Item Name: Replacement Skidtube

DRAWING NO. D2650	TITLE 206/407 SKIDTUBE ASSEMBLIES	REV. F	DART AEROSPACE LTD ENGINEERING ORDER		D.E.O. NO. D2650-F-1	SHEET NO. SHEET 1 OF 1	SCALE NTS
DRAWN	CHECKED	MFG. APPR.	APPROVED		DE APPR.		
DATE 12.10.12	DATE 12.10.22	DATE 12.10.22	DATE 12.10.22		DATE 12.10.22

CHANGE C'BORED WELDED CROSSBOLT SPACERS TO SWAGED SPACERS

AMENDMENT TO DETAIL B
NOT TO SCALE

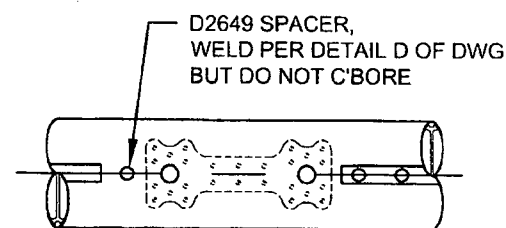
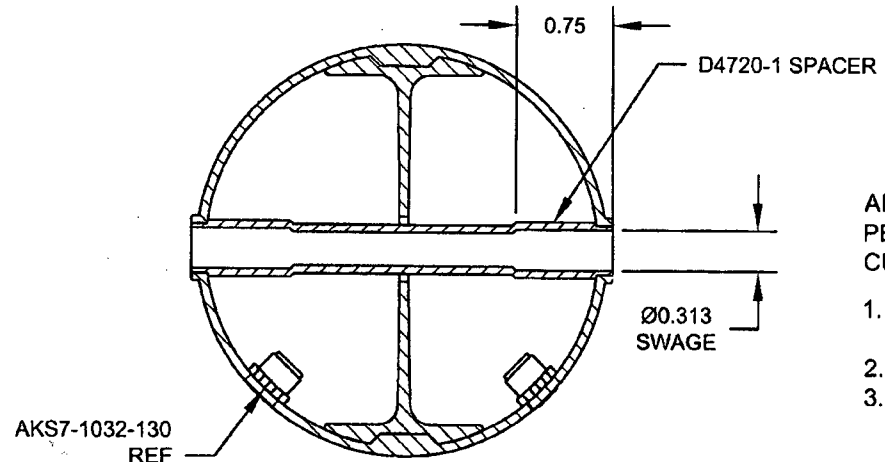
ADD DETAIL G BELOW, WHICH IS THE SAME SECTION VIEW AS DETAIL D OF DWG.
C'BORED HOLES ARE **NOW SWAGED** PER DETAIL G BELOW. FOR THE Ø0.375 HOLE THAT IS NOT C'BORED, WELD PER DETAIL D OF DWG (SEE AMENDED DETAIL B FOR REFERENCE).
